EXHIBIT "A"
SB-20120008
ST. LUCIE NORTH DRAINAGE BASIN IMPROVEMENTS
GENERAL REQUIREMENTS

**CONSTRUCTION PLANS
 OF
 ST. LUCIE NORTH DRAINAGE
 BASIN IMPROVEMENTS
 FOR
 CITY OF PORT ST. LUCIE, FLORIDA
 LYING IN
 SEC. 6, 11-13, 17&18, TWP. 36S., RNG. 39&40 E.
 ST. LUCIE COUNTY, FLORIDA**

Job No.: 779.1.1
14 OF 26 SHEETS

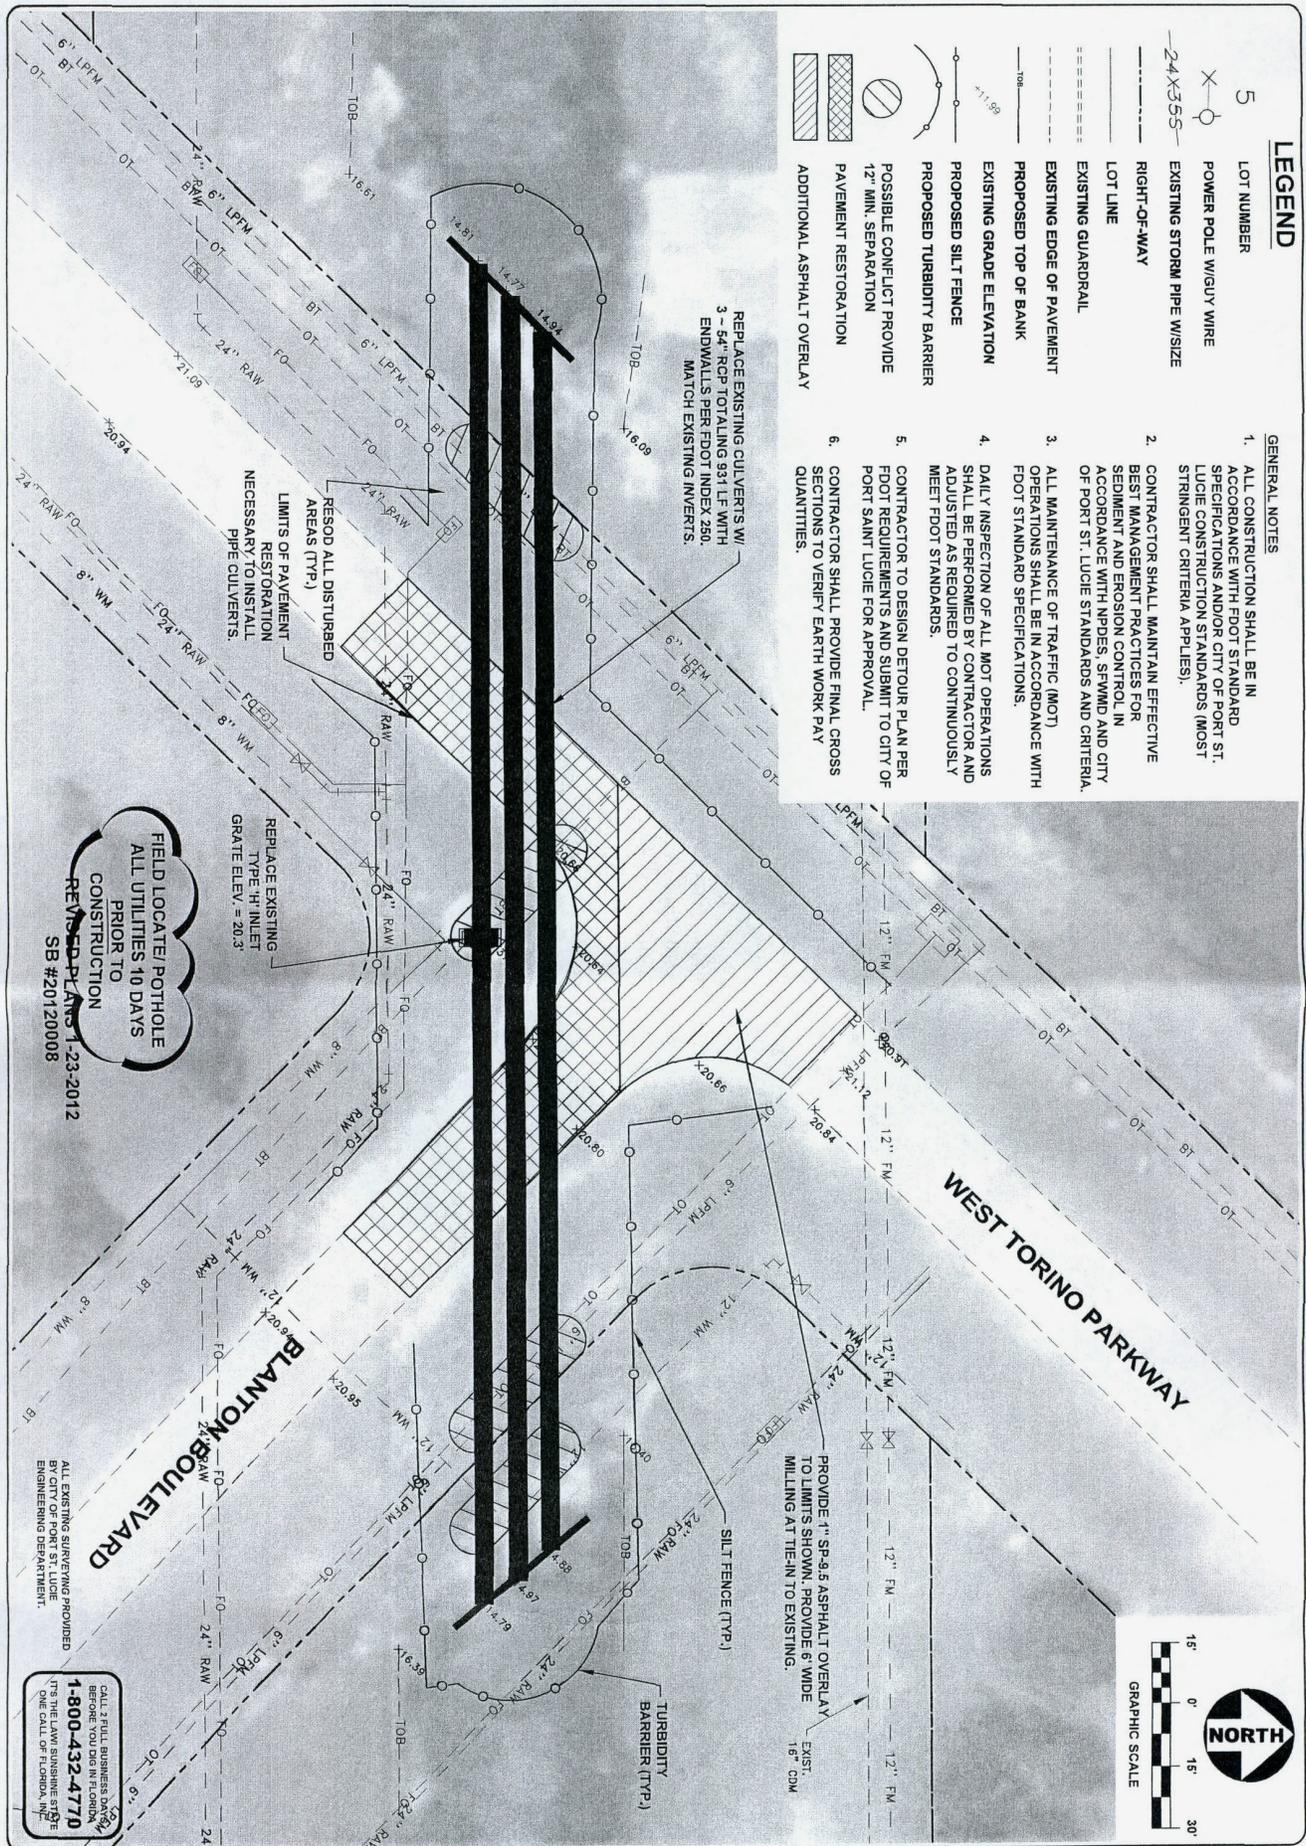
Q6. On sheet 14 of the plans. We found from our site visit that the existing outfall pipe is undermined and probably collapsing, which indicates inadequate conditions for the proposed metered end section. How will you propose the new structure be supported. Is there any provisions on soil under this particular structure?
